# CITY OF SAN ANTONIO

Re: Westover Valley Subdivision (Amendment) MDP # 762A

The City Staff Development Review Committee has reviewed Westover Village Master Development Plan (Amendment) M.D.P. # 762A. Please find enclosed a signed copy for your files. Your plan was accepted, however please note the following:

# AMMENDMENT TO WESTOVER VALLEY SUBDIVISION

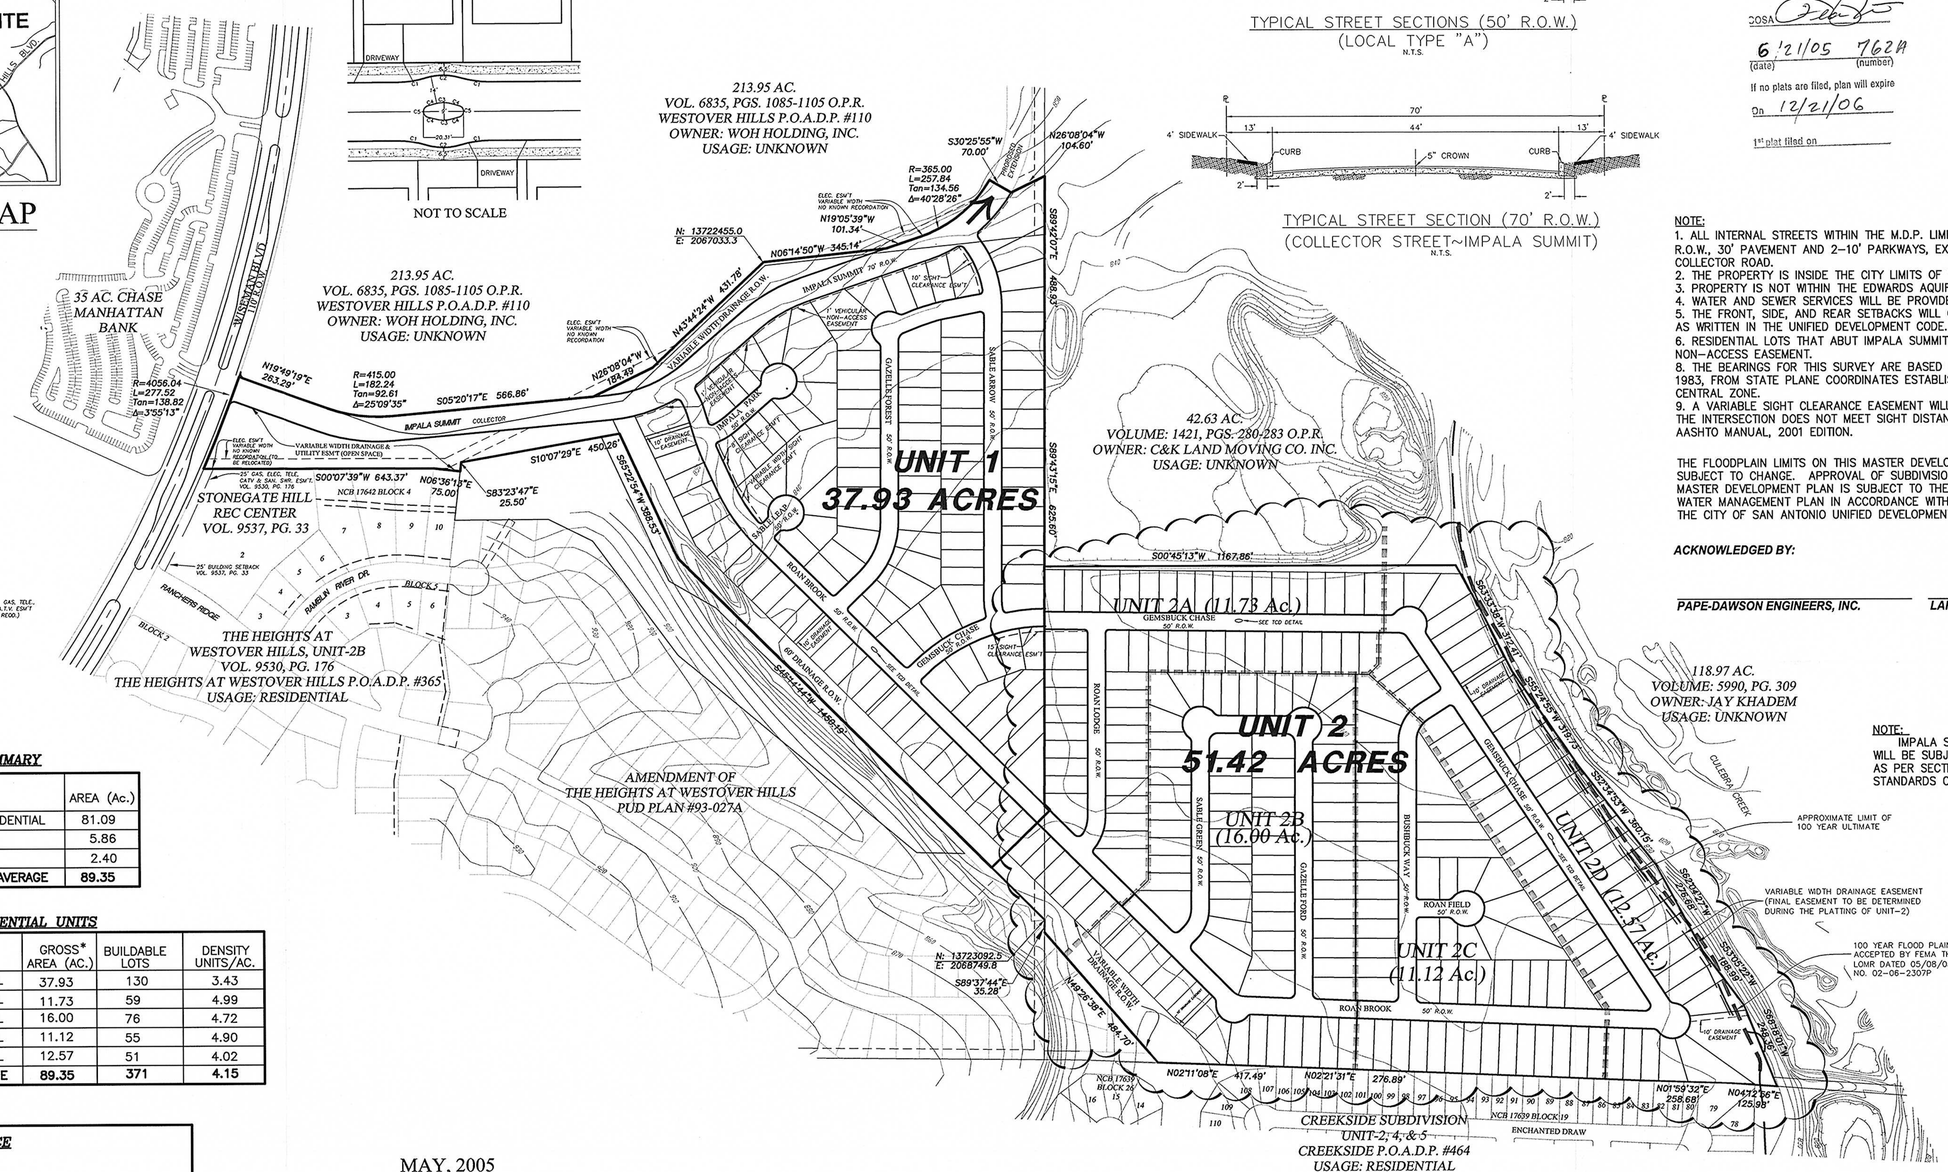
- In consideration of public safety and convenience, excessive grades by reason of topography should be avoided in street layouts and arrangements.

1. This includes such items as intersection sight distances, street design and pavement requirements, traffic calming, cul-de-sac requirements, knuckle requirements, and right-of-way requirements.

2. This property is proposed to composed to consist of 371 single family detached homes. Based on the 6th edition of the ITE Trip Generation Manual, this property is estimated to generate 381 peak hour trips. A new collector street will be provided at an existing median opening on Wiseman Blvd. extending to the north edge of the property which will eventually continue to Rogers Road. Two access points will be provided into the new collector street. A stub-out street will provide additional connectivity to the east portion of the property.

1. The existing median opening on eastbound Wiseman Blvd. shall be modified to provide a minimum of 153 feet of storage capacity.

2. The proposed collector will have a minimum of 70 ft. ROW with 44 ft. pavement and shall be extended from Wiseman Blvd to the northern portion of Unit One.

1. Westover Valley is a proposed subdivision of 371 residential units. Base on Section 35-503 of the UDC, the park dedication requirement for this development is 3.4 acres.

2. Prior to the recordation of the first plat filed under this Plan, a fee in-lieu of dedication in the amount of $36,706.50 is to be paid to the Parks and Recreation department prior to the recordation of the first plat filed under this plan.
